TECHNICAL DRAINAGE STUDY UPDATE NO.2

Sunstone Phase 1 Infrastructure

Subject: Technical Drainage Study Update No. 2 for Sunstone Phase 1 Infrastructure

Purpose: The purpose of this Update 2 Study is to provide hydraulic analysis of revisions due to conflicts in design for two areas: storm drain within Moccasin Road and a lateral within Sky Pointe Drive.

G-4
SHEET 13 OF 12

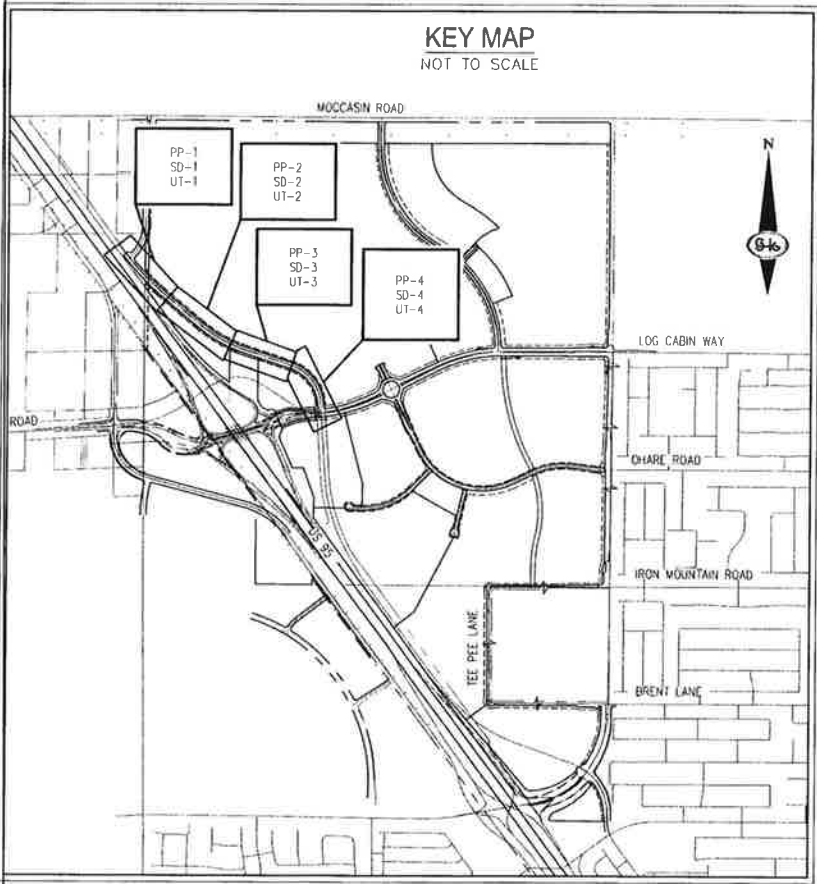
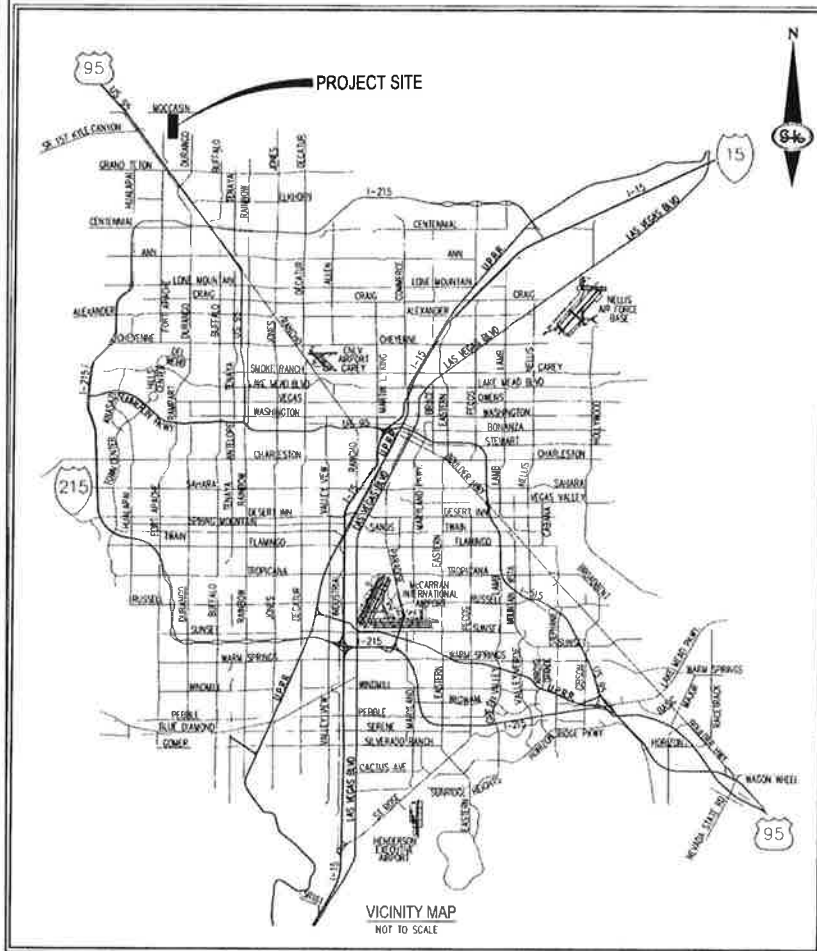
Upon construction of the regional storm drain within Moccasin Road, the existing point of connection to the Moccasin facility west of the intersection of Skye Canyon Park Drive and Moccasin Road was located several feet southwest of the anticipated location. The proposed storm drain within Moccasin Road therefore has been revised to match the existing point of connection. This change affects two lengths of pipe and two manhole inverts (SDMH#19 & #20) within the Moccasin storm drain alignment.

Portion of storm drain revised with Update 2 Study

Hydraulics: The WSPGW model (NRC3.WSW) for the storm drain revision and the lateral loss computation for SDDI#5 has been revised and is included in Appendix B. Markups of the original approved drainage plans are provided in Appendix A to illustrate the changes proposed with this Update 2 Study. Note that within the Moccasin Road storm drain revision the flow in the storm drain system has not changed and the hydraulic grade line and velocity only changed for the two pipes and the revised connection stub. The proposed storm drain hydraulic changes are relatively minimal and still meet original requirements for the storm drain including maintaining the HGL at least 1-ft below finished grade and not increasing the amount of sacrificial concrete already proposed.
